Subject: **PALO VERDE SOLAR I, LLC'S OPENING TESTIMONY**  
**BLYTHE SOLAR POWER PROJECT**  
**DOCKET NO. (09-AFC-6)**

Palo Verde Solar I, LLC's

Opening Testimony

**Blythe Solar Power Project (09-AFC-6)**

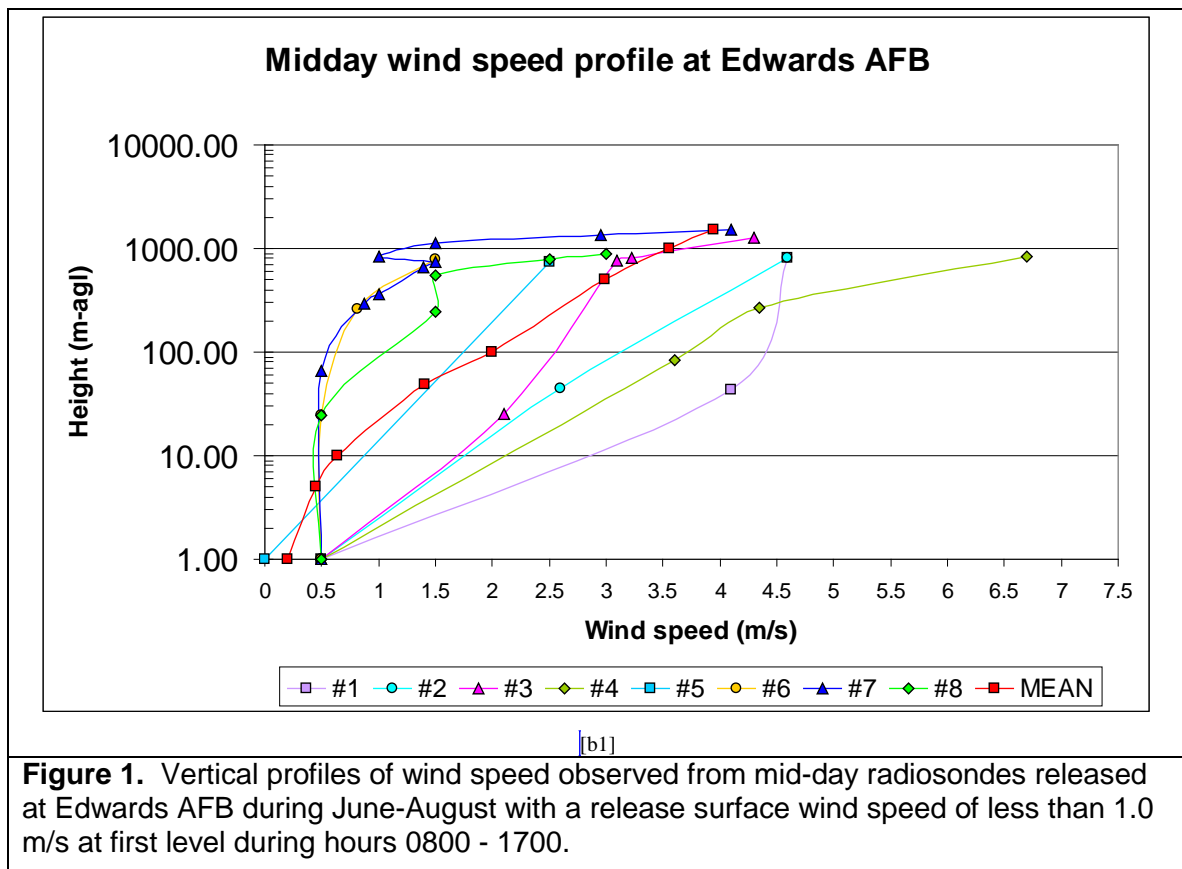
A basic assumption in the Briggs' formulation of plume rise is that the plume is axisymmetric, or symmetrical around the vertical axis of rise. However, the ACC is a structure that prevents symmetry about the vertical axis. Because the linear structure of the heat exchangers is a linear A-frame arrangement, there is direction-dependent entrainment of ambient air into the plumes that leads to direction-dependent rise and turbulence fields surrounding the plume. These non-symmetrical influences are not accounted for in the Briggs' formulation. In addition, the A-frame lattice and cooling tubes/fins of the heat transfer surface essentially creates a diffuser above the ACC that tends to distribute vertical flow evenly across the entire surface of the ACC, a surface of approximately 100m x 75m, compared to a typical power plant stack that may have a diameter of 10m.

Based on the above preliminary analysis, it appears that the Briggs' formulation of plume rise is inadequate for simulating the rise, and vertical velocity profile, in a plume above an ACC because of violations of the basic assumptions inherent in the model. To simulate plume rise accurately above an ACC, a fully developed non-axisymmetric integral plume rise model would be needed to model the rate of vertical wind speed and turbulence decrease with height above the unit.

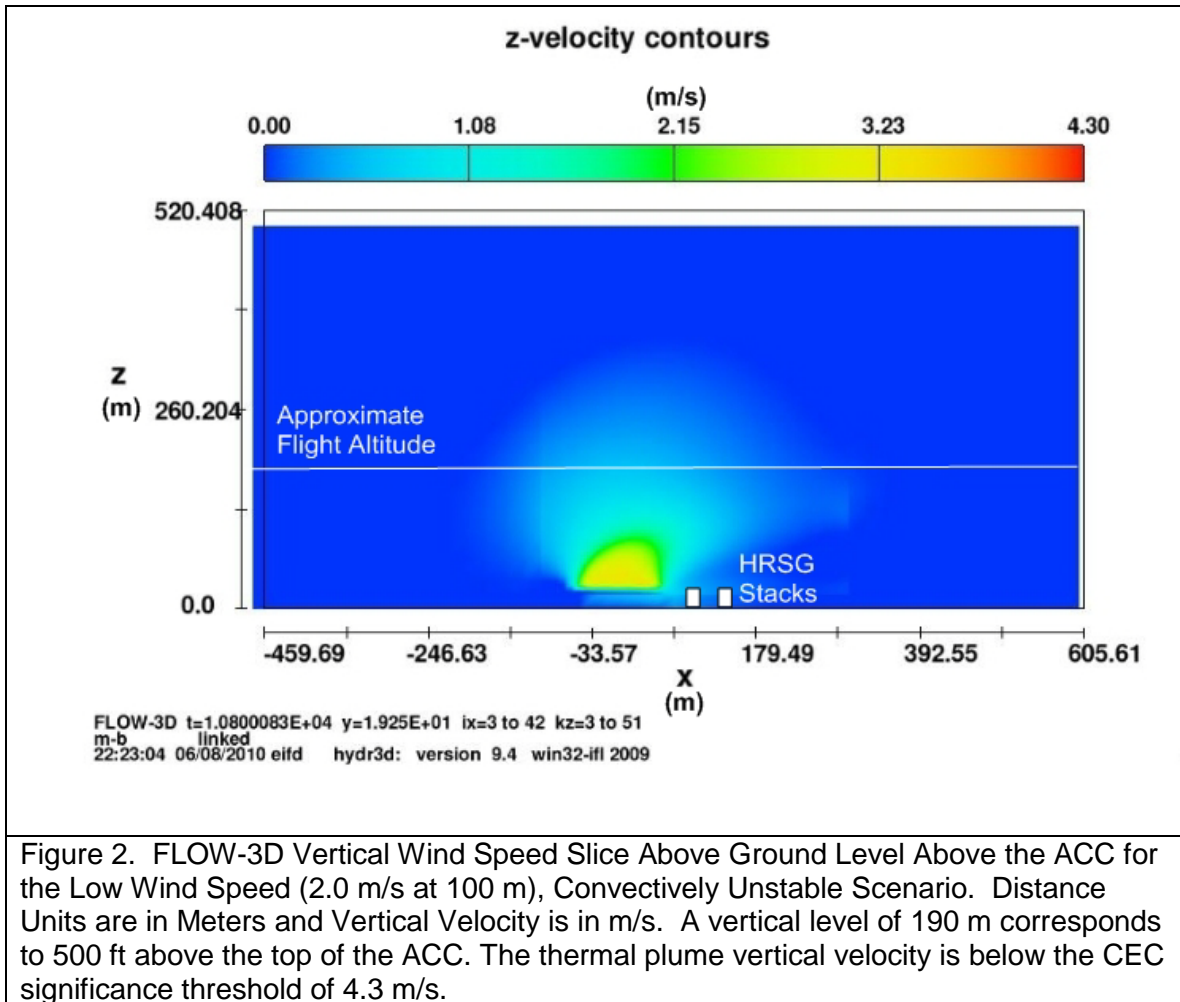
Figure 2 presents a plot of the FLOW-3D modeling results of the vertical velocity (m/s) versus height above the ground (m) for a horizontal slice north-south through the long axis of the ACC for the preliminary scenario discussed above. Nowhere in the modeling domain above the ACC does the vertical velocity exceed the significance threshold of 4.3 m/s for turbulence established by the CEC, even at the release point on top of the ACC. Figure 3 presents a view of

the vertical profile of temperature through the plume. On both figures, the flight altitude is annotated. Figure 4 presents block figures of the ACC model incorporated into the FLOW-3D simulation. The left diagram presents a view of a single fan cell of the ACC. The right diagram presents a view of the ACC from the top and from the bottom showing the 45 cells in a BSPP ACC.
